UNITED STATES PATENT AND TRADEMARK OFFICE

| APPLICATION NO. | FILING DATE | FIRST NAMED INVENTOR | ATTORNEY DOCKET NO. | CONFIRMATION NO. |
|--------------------------------|-------------|----------------------|---------------------|------------------|
| 10/780,424 | 02/17/2004 | Clayton C. Bohn JR. | 5853-401 | 2023 |

Office Action Summary

DETAILED ACTION

Fig. 2(a)

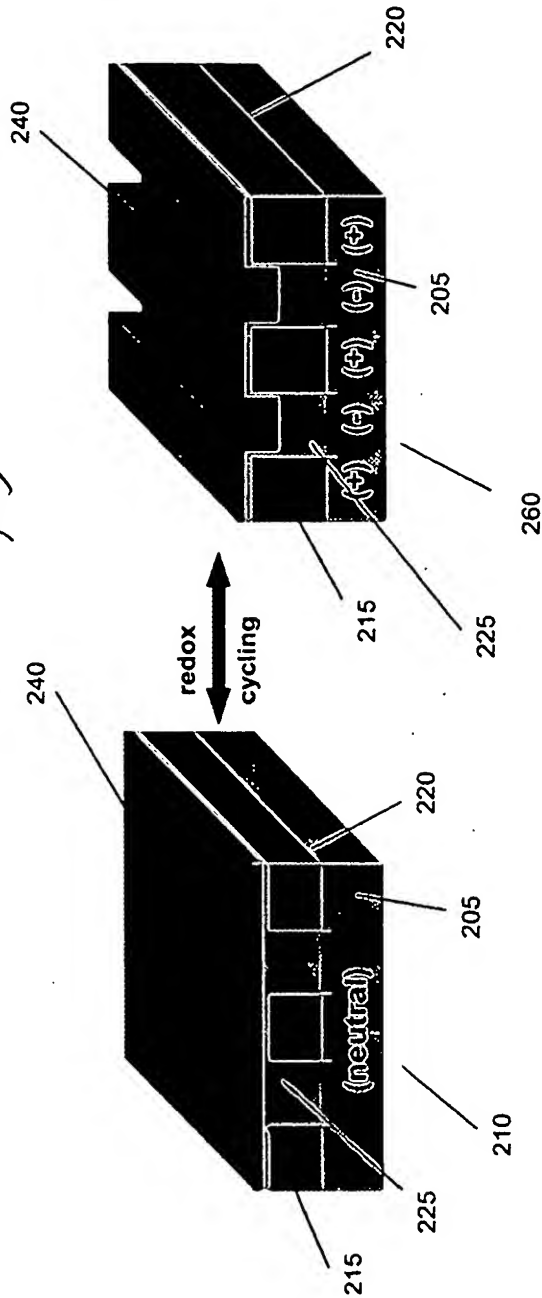
2. With regard to the replacement sheets of drawings filed October 17, 2006, the sheet with figures 2a and 2b is not approved, the sheet with figure 3 is not approved, the sheet with figures 4a-4d is not approved, the sheet with figure 6 is approved, the sheet with figure 8 is not approved, and the sheet with figure 9 is approved. The sheets not approved because of the dark shading are unclear, especially figures 4a-4d and figure 8. The shading should be removed from these figures.
3. In review: figures 2a, 2b, 3, 4a-4d and figure 8 are NOT approved;
figures 6 and 9 ARE approved.

Not
Approved
App 10/1/05
10/31/05
Ceb
983

Fig. 3

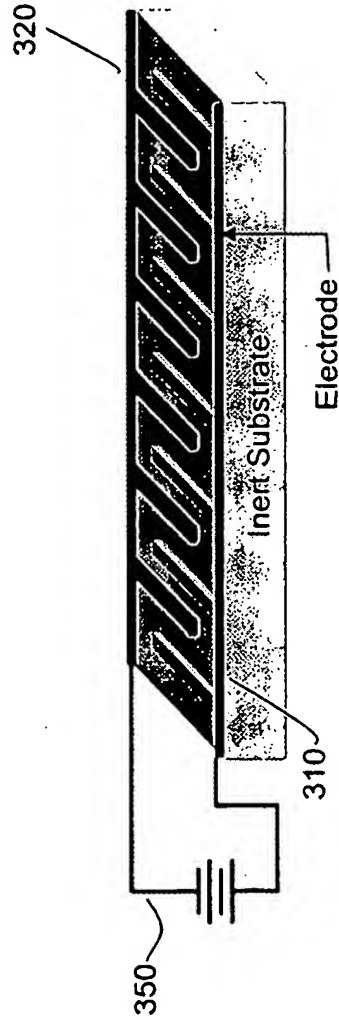
Not
Approved
10/31/05
